UNITED STATES
DEPARTMENT OF THE INTERIOR
GEOLOGICAL SURVEY

Federal

Bell Petroleum Company

17. DESCRIBE PROPOSED OR COMPLETED OPERATIONS (Clearly state all pertinent details, and give pertinent dates, including estimated date of starting any proposed work. If well is directionally drilled, give subsurface locations and measured and true vertical depths for all markers and zones pertinent to this work.) *

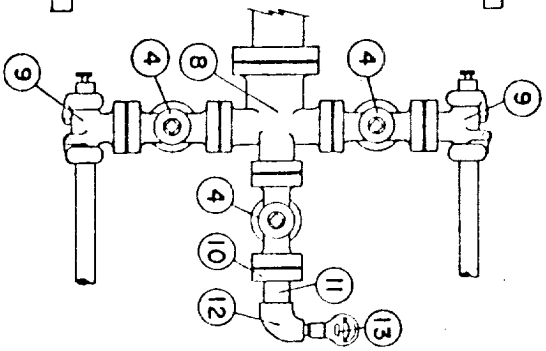
Flow Line Will Have To Be
Made To Fit Groove
Rotary
